The Residences at 130 Cambridge Park Drive
Supplement to Special Permit Application

The McKinnon Company *on behalf of* BRE/CPD, LLC // Cambridge, MA // 16 May 2013

Subject Supplement to Special Permit Application

Figure-Ground of Future Built-Out Open Space

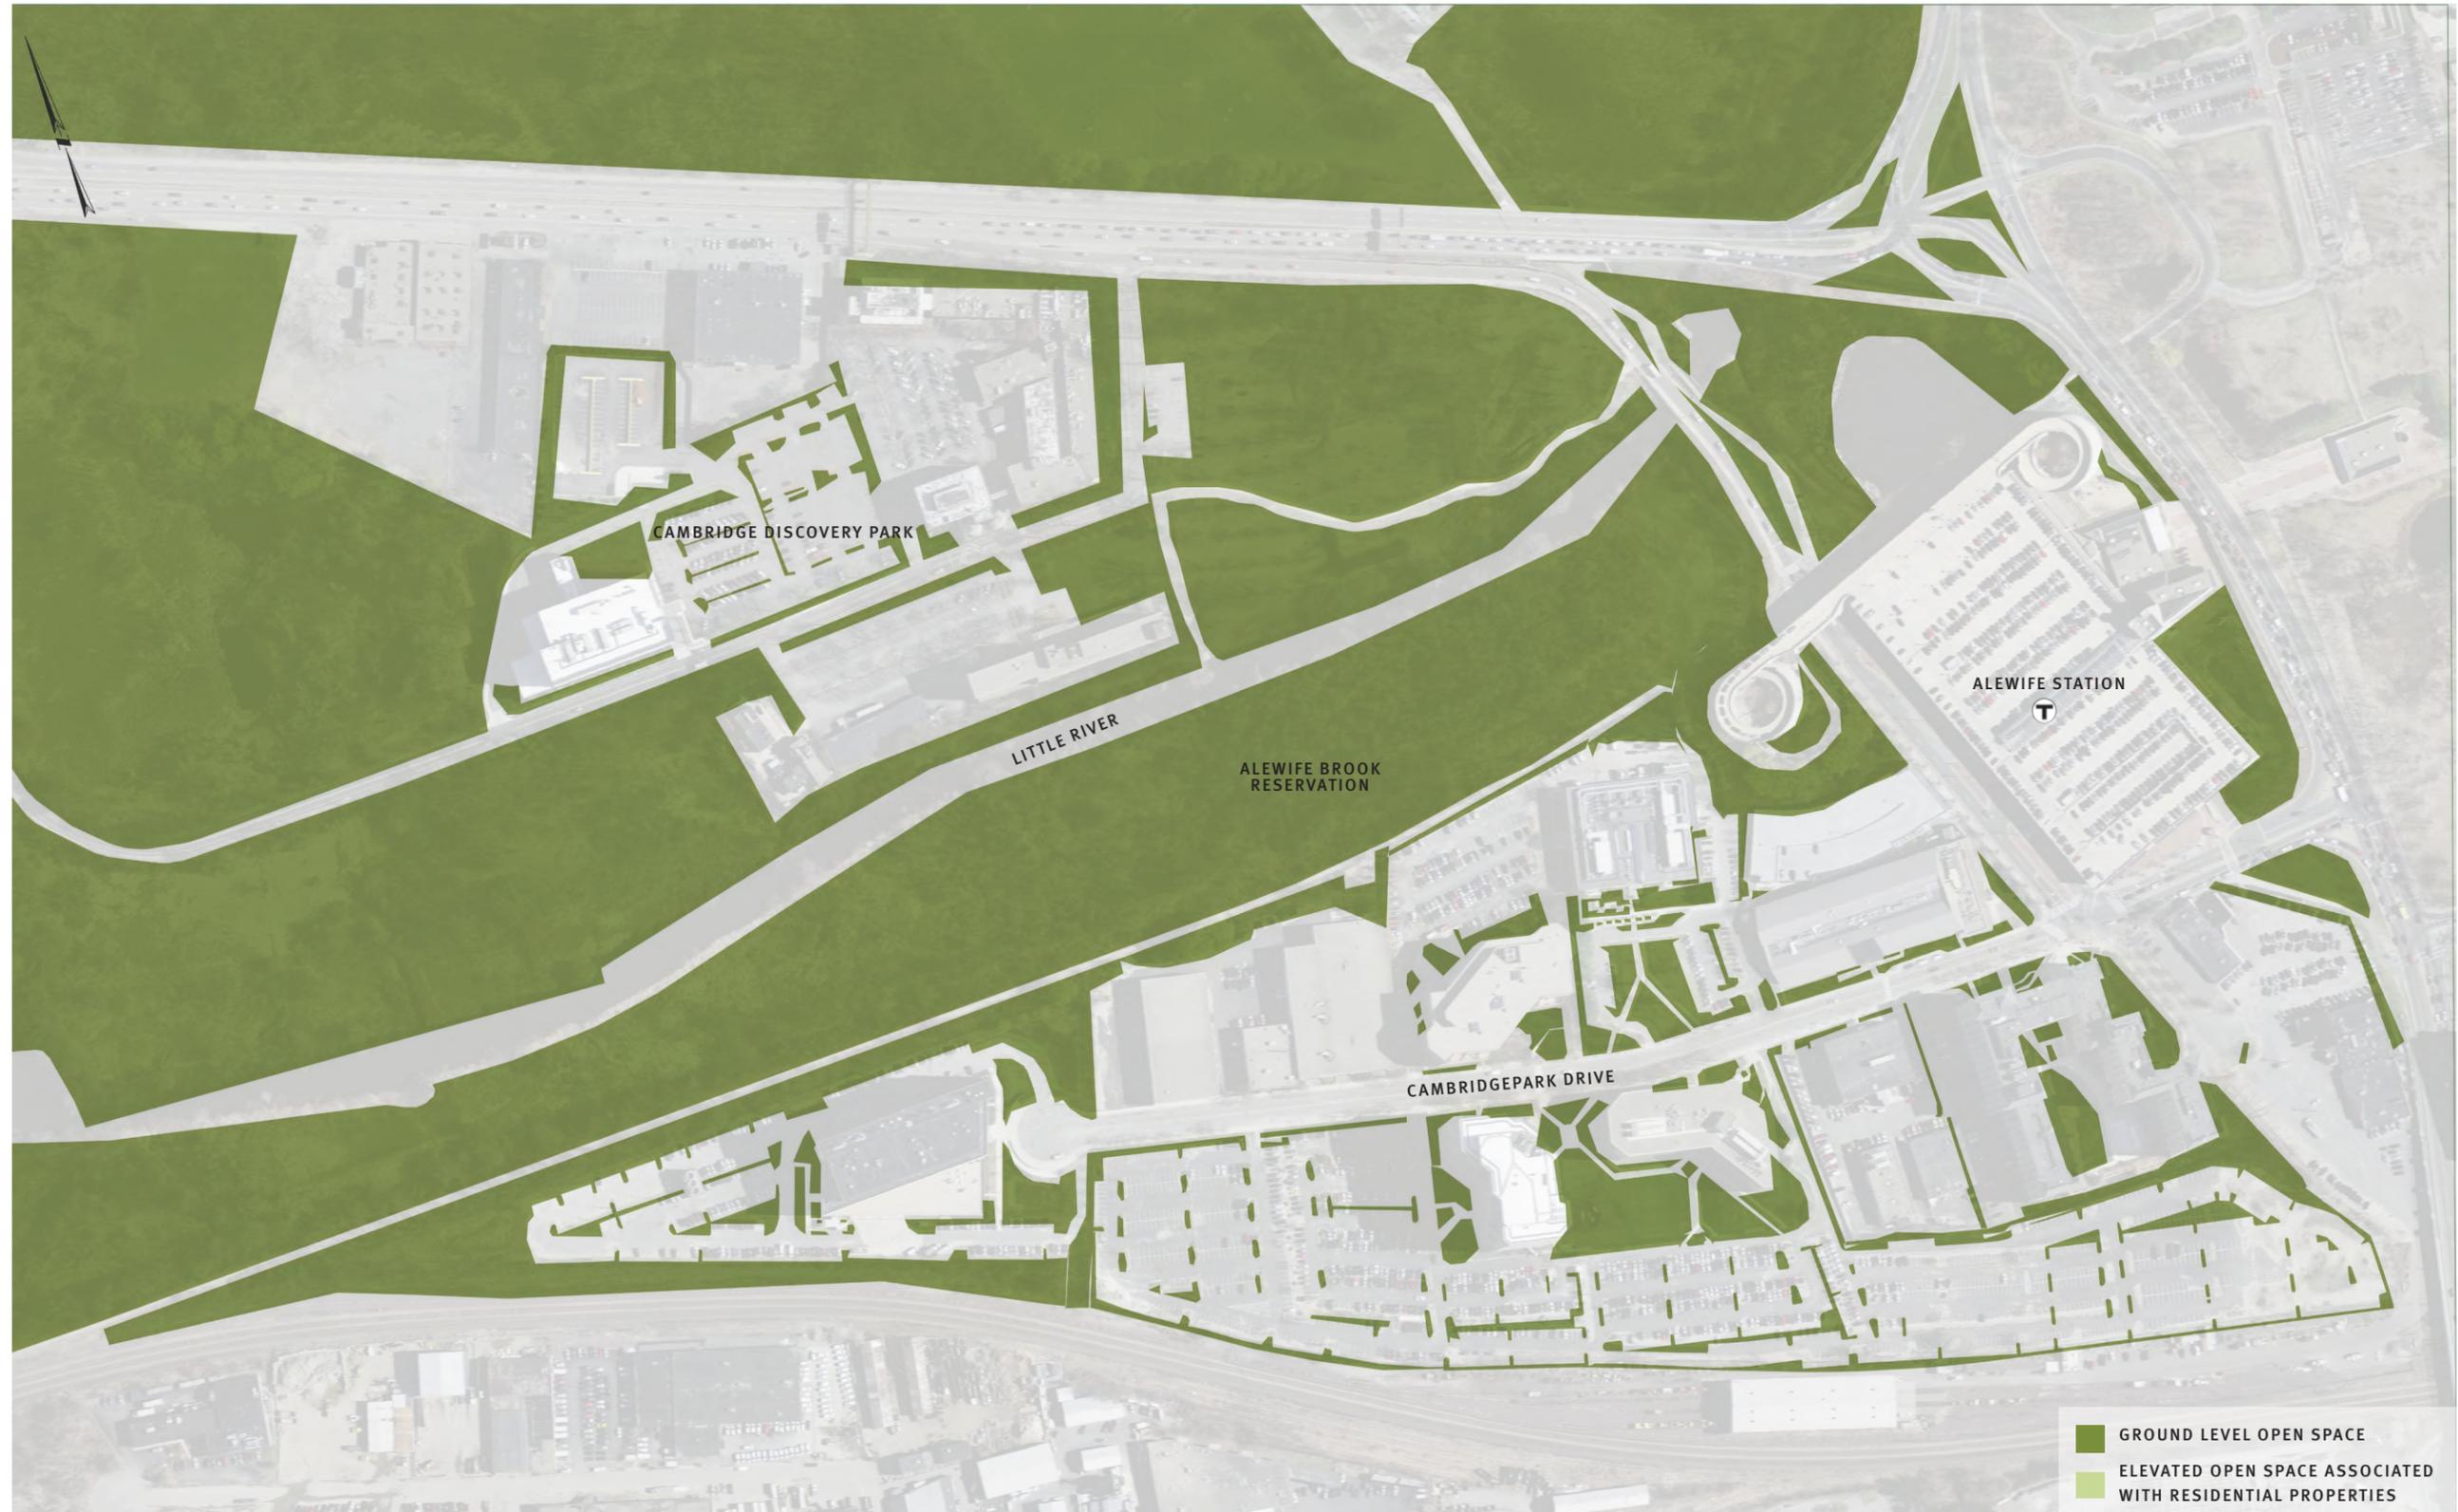
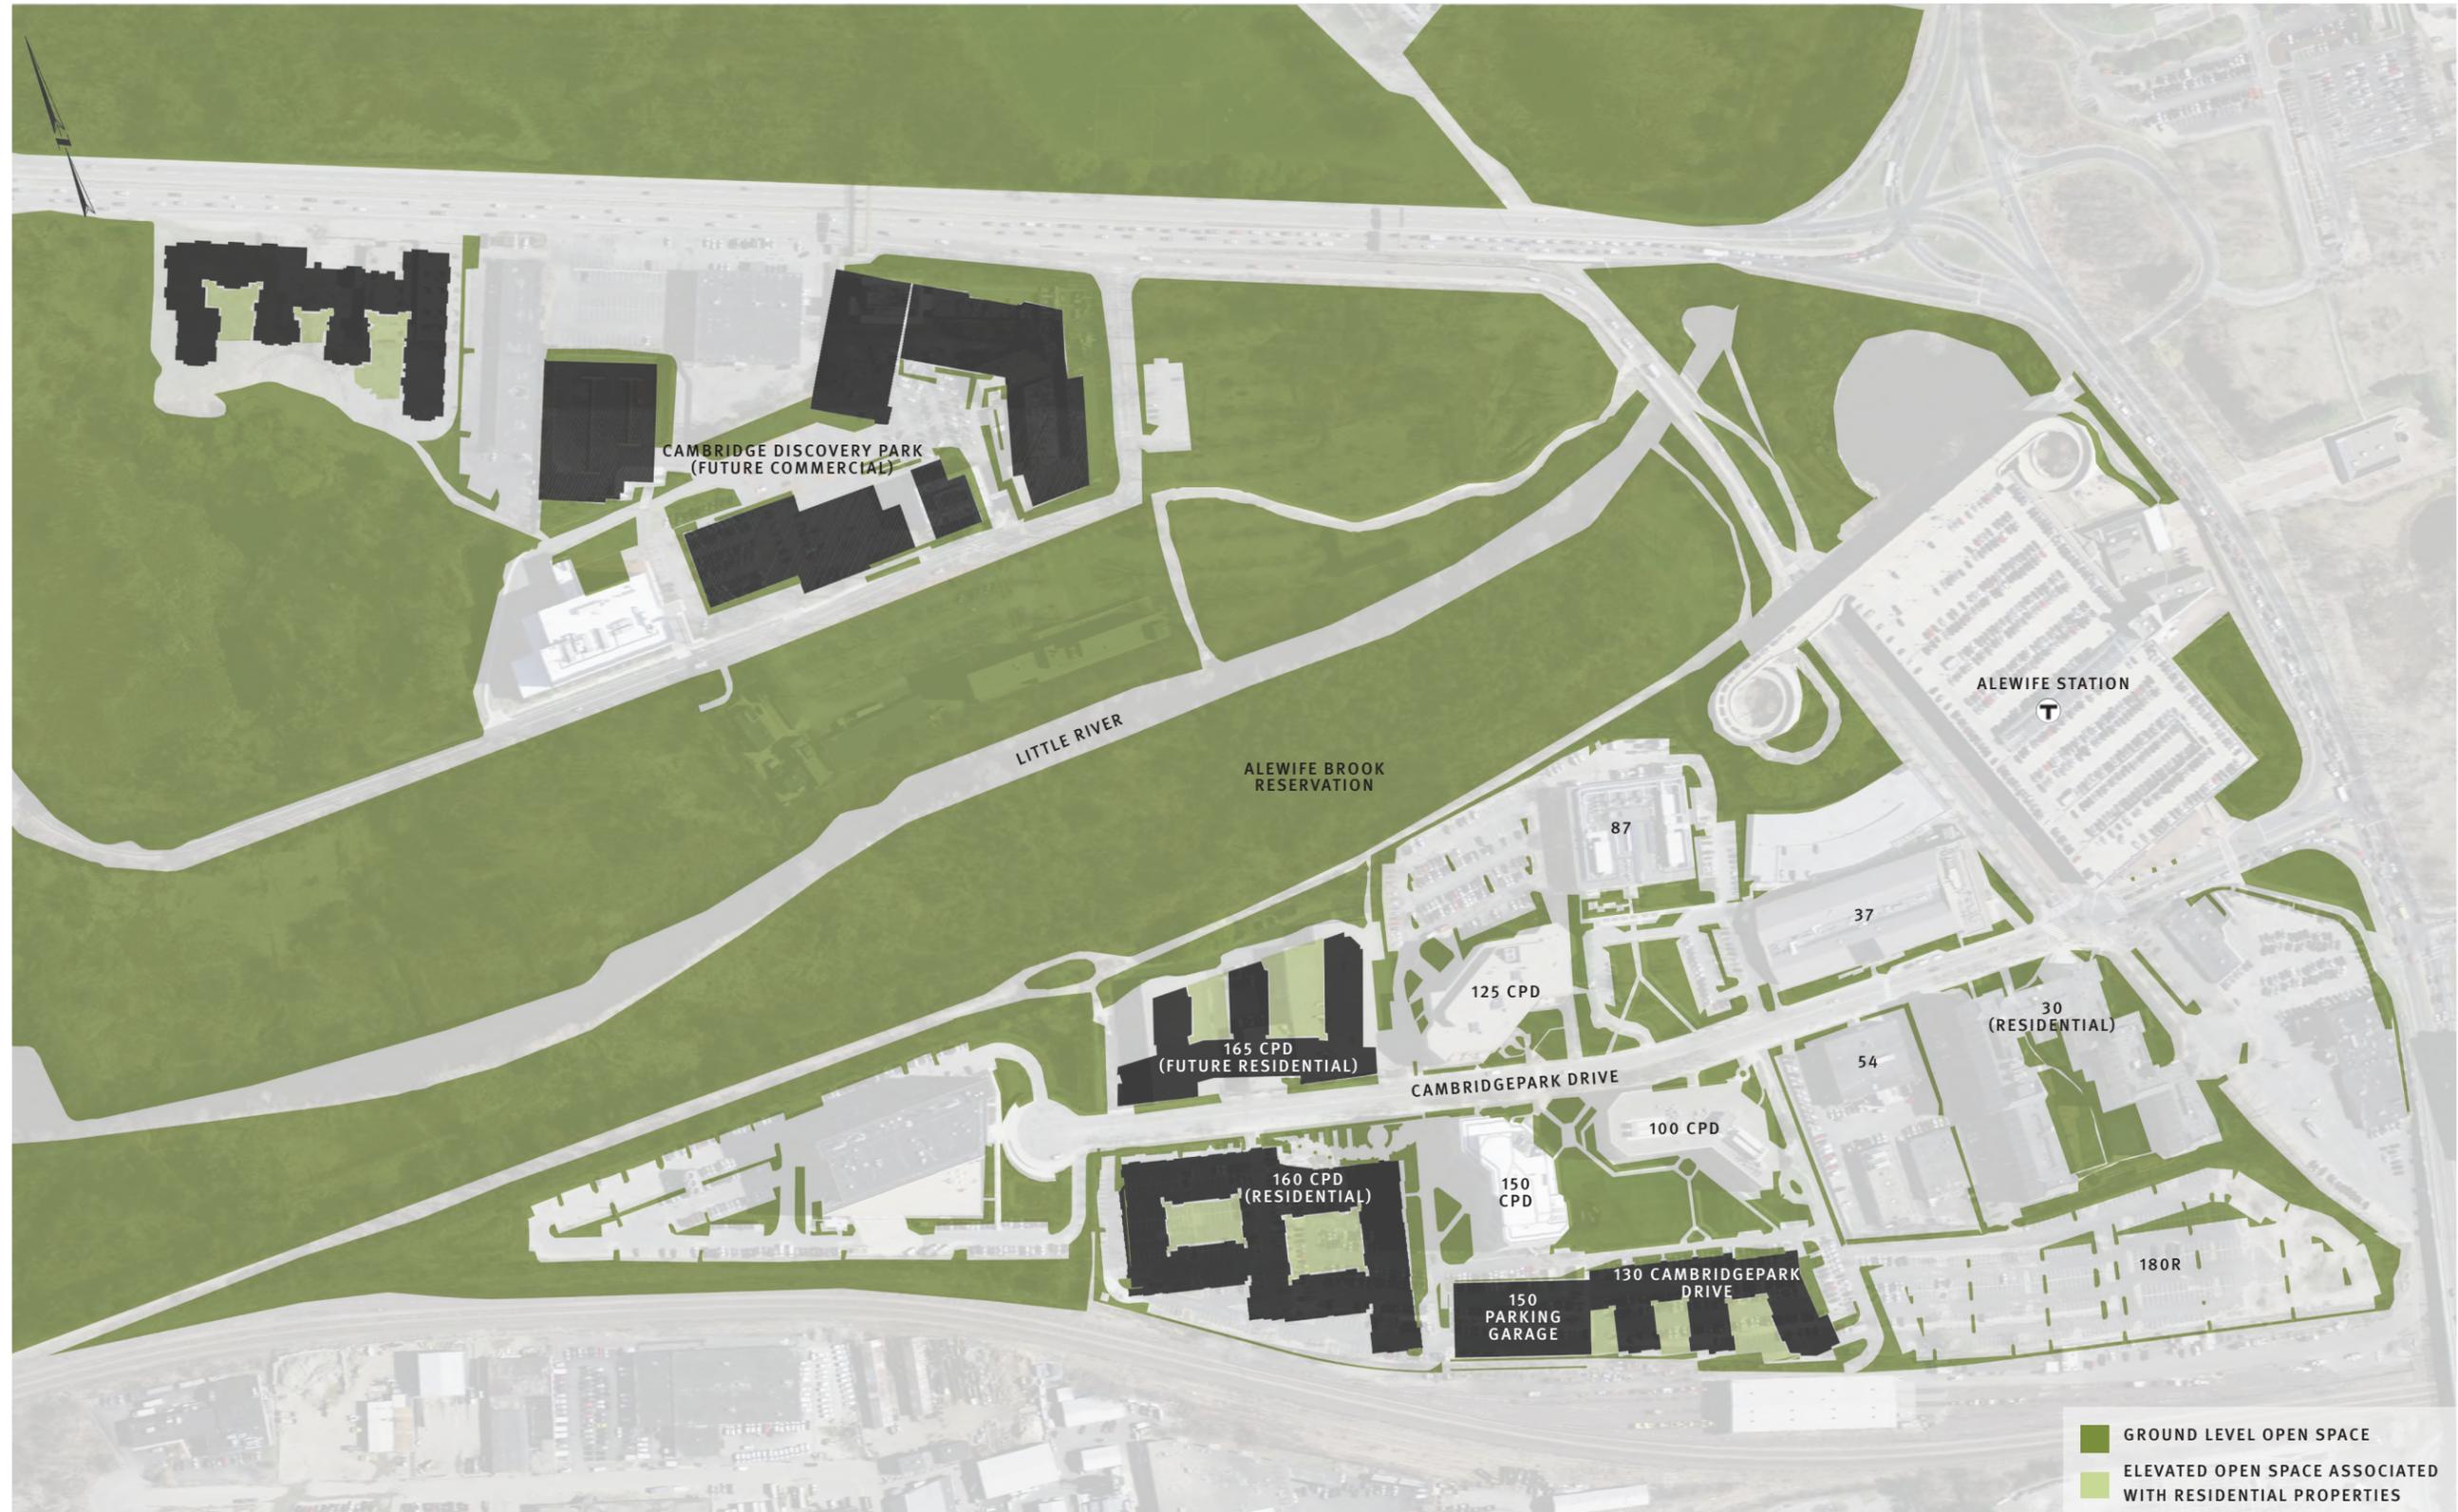
Please illustrate and discuss the surrounding environmental context with an overview Open Space site plan of the Triangle and the adjacent Special Districts 4 & 4A.

The maps on the following three pages compare the relationship of open space between the existing (pre-residential development) condition and the final proposed condition. We included Cambridge Discovery Park within this open space and pedestrian network since this area is closely related to the residential development at Cambridgepark Drive.

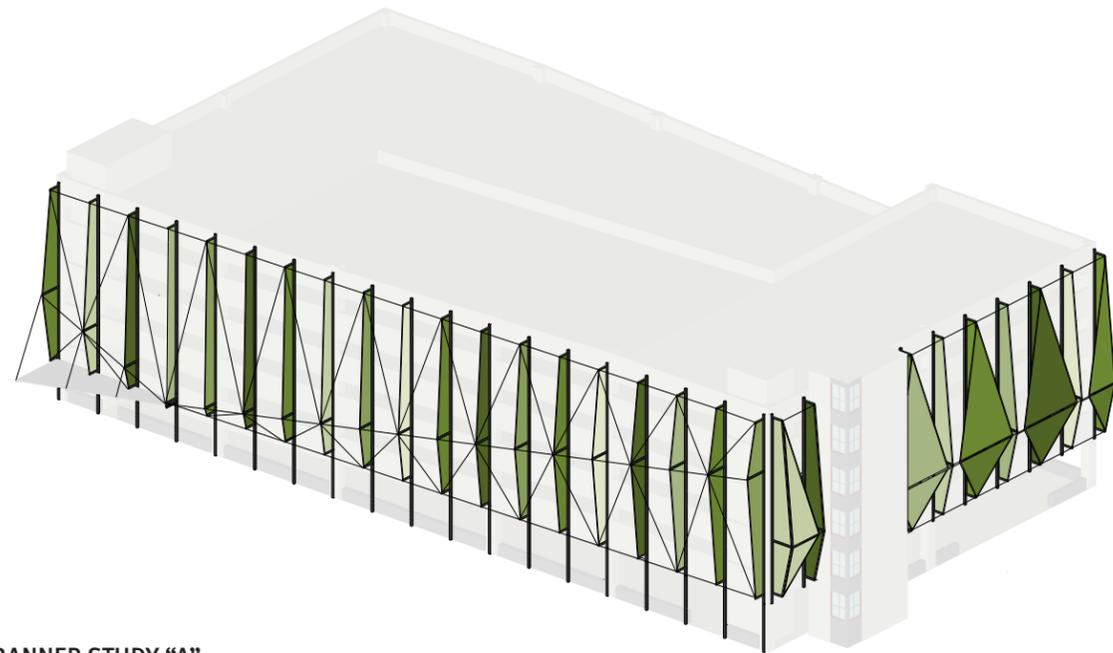
Would you explore a variation on your banners, perhaps some variety in the shape and/or color?
Also, a sample of the fabric and some discussion as to the wear and tear over time would be useful.

The banner design, as currently proposed in the Special Permit Application and shown on this page, was designed to appear as a continuous, translucent surface across the garage, adding a splash of color to the north and west facing facades and emphasizing the pedestrian and vehicular entrances. Each banner was designed as a slightly different shape; by making slight adjustments to the geometry of these banners across the length of the facade, we are able to imply a sense of movement across the northern facade which is read in a diagonal line and subtly cast shadows. Mounting the banners perpendicular to the facade also allows us to create a more three-dimensional facade and a more engaging streetscape. On the west facade, facing 160 Cambridgepark Drive, we designed the garage banners to be mounted parallel to the facade, to screen the garage from the more frontal view of the residential units across the street. Changing the banner orientation on the west side also helps us emphasize the main vehicular entrance into the garage.

Exhibit A

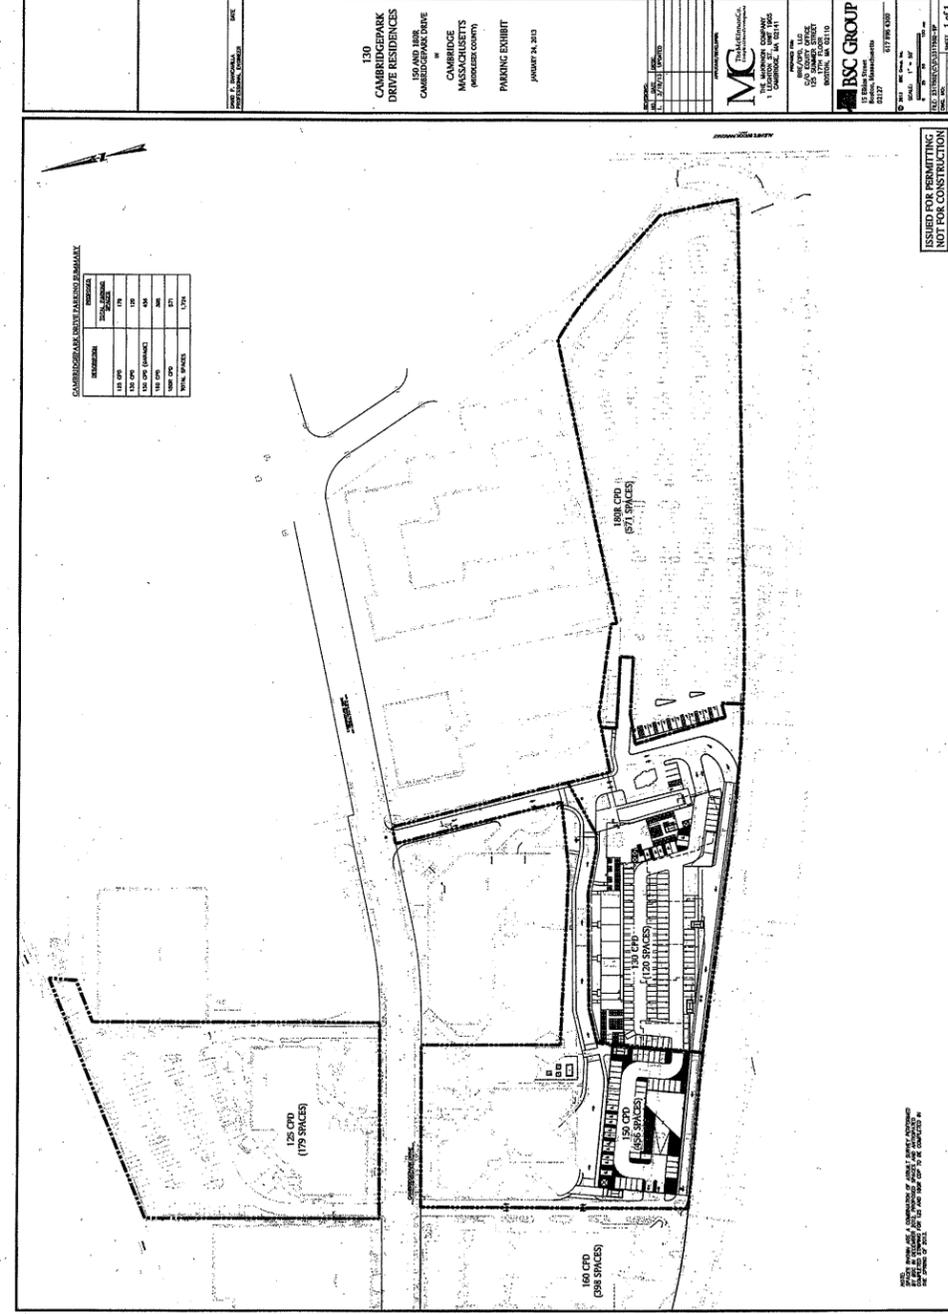
Exhibit A attached shows our detailed parking recommendations including the physical location of spaces and who can and cannot use the spaces.
